2. <u>Bylaws for Rezoning Application No. 00487 for 1144, 1148, 1152, & 1154 Johnson Street and 1406</u> <u>Chambers Street</u>

Subject: Rezoning Application No. 00487 for 1144, 1148, 1152 and 1154 Johnson Street and 1406 Chambers Street – Application Ready to Proceed to Public Hearing

Thank you for taking the time to review our proposed project response to the application review process for the subject site encompassing 1144-1154 Johnson Street and 1406 Chambers Street. The following are the questions or comments identified by City Staff along with our corresponding responses. For visual clarity, this letter is intended to be read with the corresponding drawings titled: Johnson + Chambers, Rezoning / DP Application Set – R.01, 22 march 2017 (and follow up set R.02, 28 April 2017).

Mie: Floor Plan Level 2

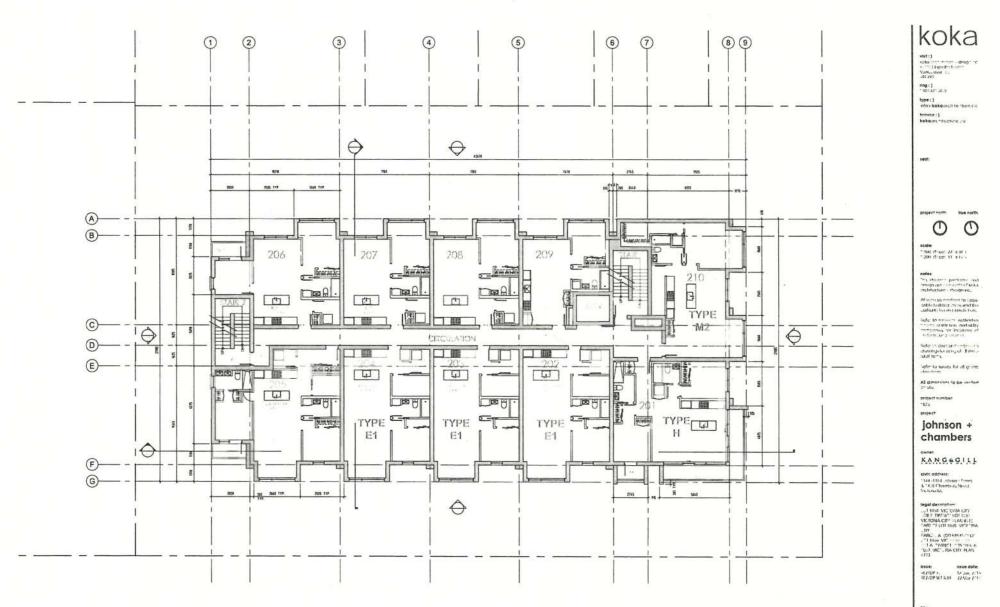
5) Please ensure floor plans and elevations are consistent with respect to window placement and size, and balconies. Some inconsistencies have been discovered on the majority of floor plans.

- The floorplans and elevations are now consistent with respect to the window placement and size, as well as the balconies. Please refer to sheets A.013, A.014, A.015, A.016, A.017, A.018, A.019, A.021, A.022, and A.023.
- Planters at the level 5 roof have also been added in the level 6 plan for consistency. Please refer to sheet A.018.
